20 June 2025

RESPONSE TO INFORMATION REQUEST FOR MATERIAL CHANGE OF USE FOR MULTIPLE DWELLING & SHORT-TERM ACCOMMODATION (X100) AT 7-9 SURF PARADE, BROADBEACH (COUNCIL REFERENCE: MCU/2025/115)

Figure 5 Tower Massing Strategies

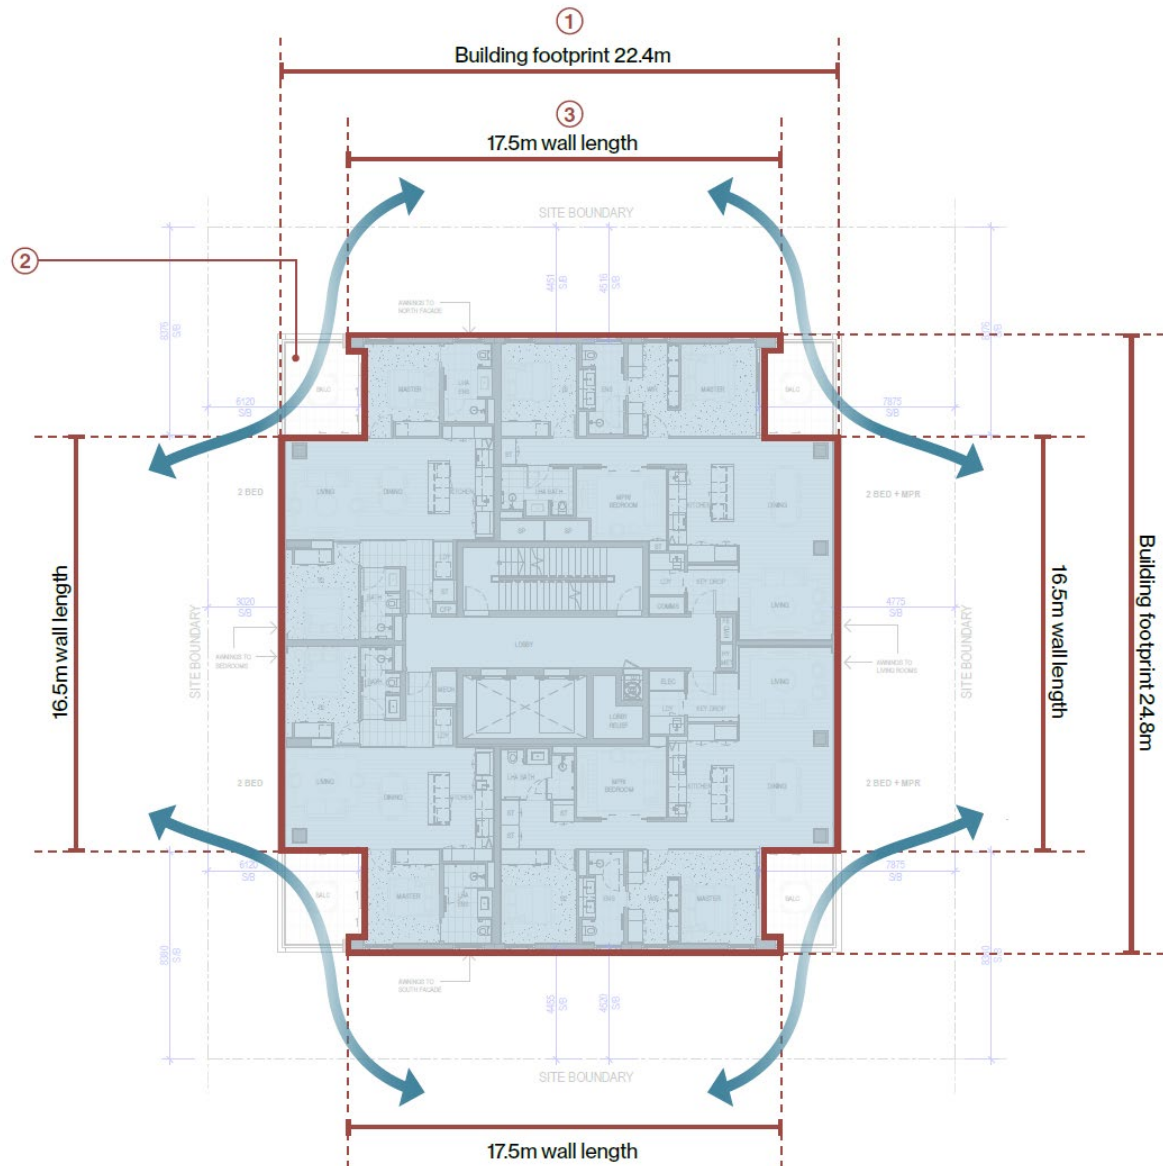
City officers are concerned with the reduced setbacks of the proposed tower to the street and side elevations, including the large site cover, lack of movement and overall visual interest for the tower form.

While officers acknowledge the tower includes interesting fine grain detailing, this is not sufficient to achieve visual relief from large rigid form and commercial like appearance. Therefore, the tower form is not considered to promote an innovative, open, attractive, and distinct Gold Coast skyline or mitigate the negative visual and physical impacts of the proposed tower.

- (a) Provide increase setbacks to the street and side elevations.*
- (b) Provide a reduced site cover.*
- (c) Incorporate greater movement to the tower form along with improved architectural detailing. City officers note that the form and detailing should assist reducing the visual mass of the tower, while promoting a subtropical residential character.*
- (d) Incorporate any wind mitigation treatments as proposed from pedestrian wind mitigation recommendations such as identified balcony glazing heights, full height screens etc.*

The subsequent site cover and setbacks have been carefully considered with regard to the site dimensions and surrounding context. As illustrated in **Figure 5** below, the tower design has limited enclosed walls interfacing at all boundaries, with 16.5m to the west, and 17.5m to the north and south. Considering this, the interface of built form to the adjoining properties and the street is relatively limited.

In this regard, the proposed setbacks to all boundaries in conjunction with the design strategies outlined above are considered to protect the amenity of adjoining uses in accordance with Overall Outcome (OO)(d)(ii) and (iii).

Figure 7 Historic Broadbeach Local Area Mapping

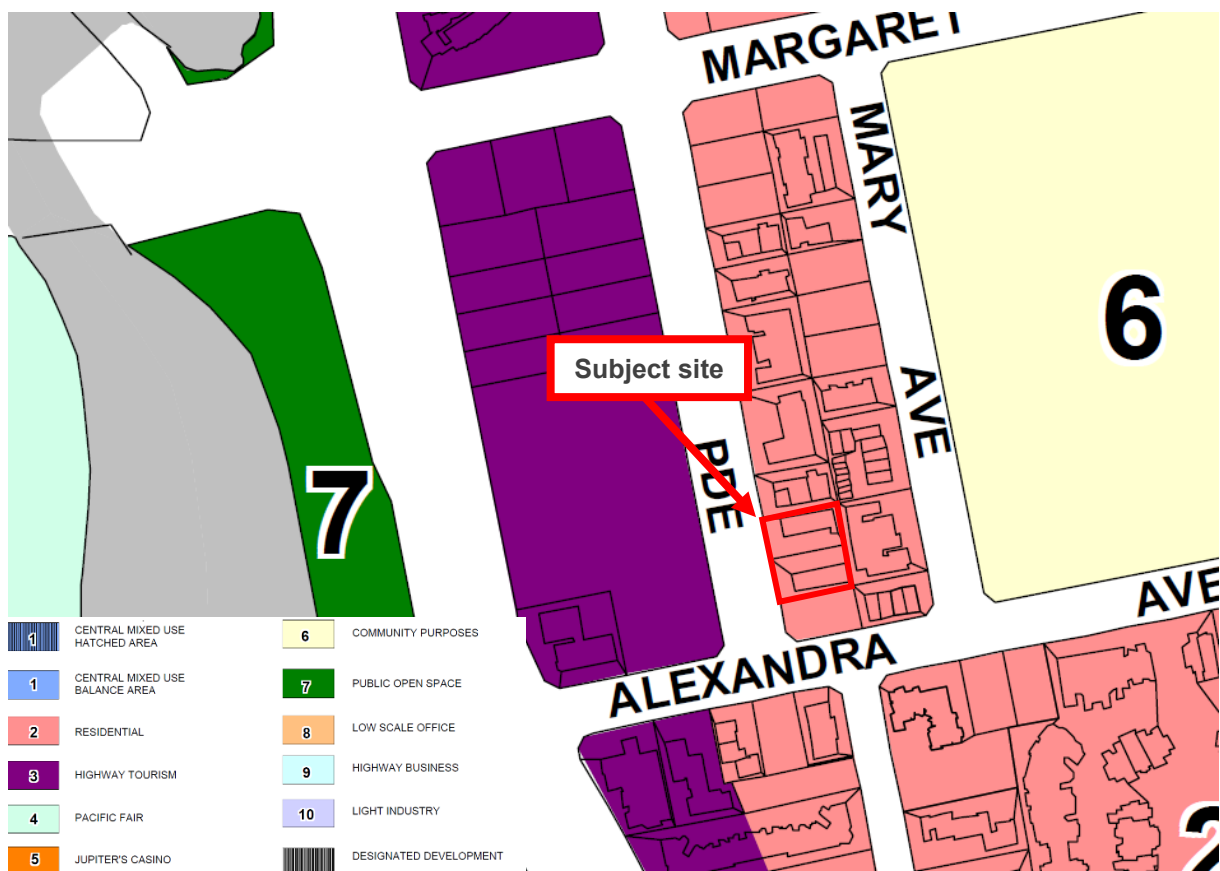
The referenced Overall Outcomes (OO)(b)(v)(vi),(vii) and (viii) of the High density residential zone code and OO(3)(a)(iii) of the Light rail urban renewal overlay code state the following:

When considering the above OOs, it is important to firstly understand the existing, intended and emerging development context in order to determine an appropriate scale and intensity of development. Under the previous 2003 *Our Living City* Planning Scheme, the subject site was located within the Residential precinct of the Broadbeach Local Area Plan, with the 'Highway Tourism' precinct located on the western side of Surf Parade, as illustrated below:

This is important to note, as this subsequently resulted in the current development character existing on and around the site today. As a result of the historic development controls, more intensive development was established within the western block of Surf Parade, while the eastern side remains low-intensity in nature, as illustrated in the aerial below:
